STAFF REPORT 10-13-2021 REGULAR MEETING

APPLICATION NUMBER: 21-7527

ADDRESS: 1441 BROOKLYN STREET (AKA KAUL GLOVE BUILDING)

SCOPE: REVISION TO PREVIOUSLY APPROVED PROPOSAL FOR GENERAL REHABILITATION INCLUDING WINDOW AND DOOR REPLACEMENT

East Elevation (Brooklyn Street) approved in 2020.

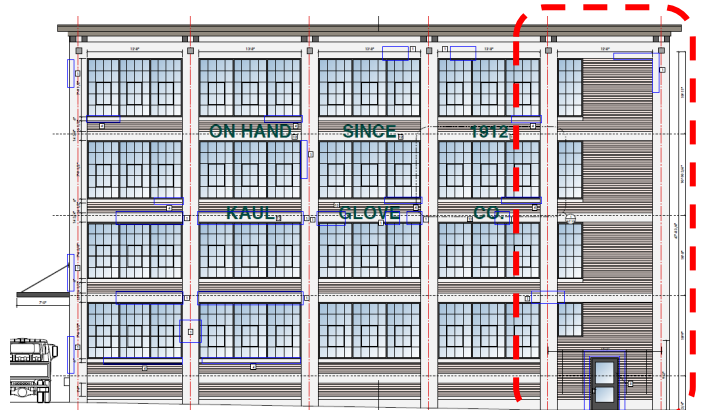
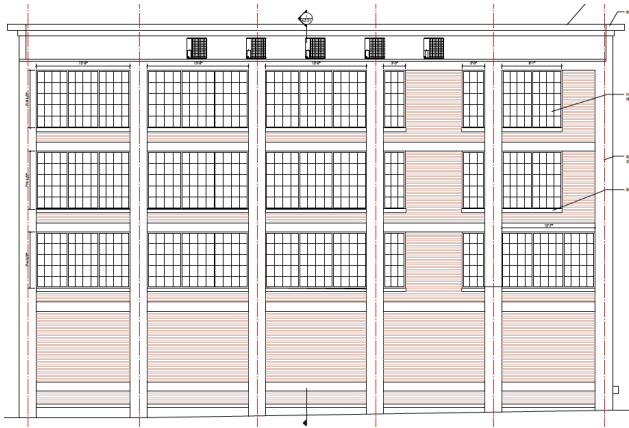
- **East Elevation (Brooklyn Street)**
 - Removal of proposed awning over main entrance at northernmost bay
 - Addition of awning at rear (south) of building

- ****Note** – the revised configuration/size of all windows in the northernmost bay (see area circled in red dashed line below) is concerning to staff as the revised proportions are inappropriate for the primary façade of the building. The structural expression of the concrete frame and large apertures within the concrete frame is an important and distinctive character-defining feature of this building. It is staff's opinion that the revision to the proportions of the windows from what was approved in 2020 is inappropriate as it doesn't meet the Secretary of the Interior's Standards for Rehabilitation, in that it alters the defining characteristics of the building and does not retain the historic character of the property.

- **East Elevation (Brooklyn Street)**
 - Staff finds that the proposed revised configuration and size of all windows in the northernmost bay is inappropriate for the historic property, its site and setting as it alters the structural expression of the primary façade which characterizes the property and is not compatible with the architectural features of the building.
 - ~~The location of the proposed stair tower is inappropriate as its visibility at the primary façade is not compatible as it doesn't protect or preserve the historic integrity of the property and its environment.~~
- **West Elevation**
 - No issues
- **North Elevation**
 - No issues
- **South Elevation (Alley)**
 - No issues

Window detail approved in 2020.

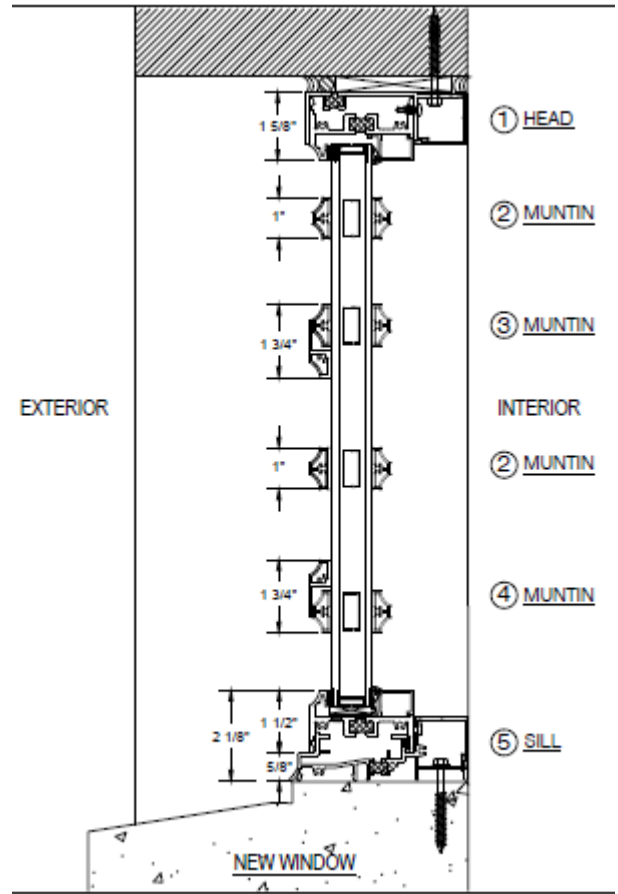
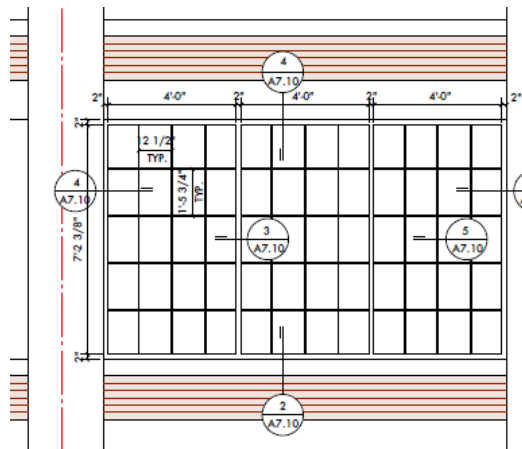
- Corktown Historic District was designated in 1984.
- Replacement window product has been revised from a Tubelite aluminum storefront system (color: anodized brown) to a Seal Craft custom aluminum window system (color: black) which includes portions of the larger window to operate, similar to historic steel windows. See additional details below and in the attached application documents.
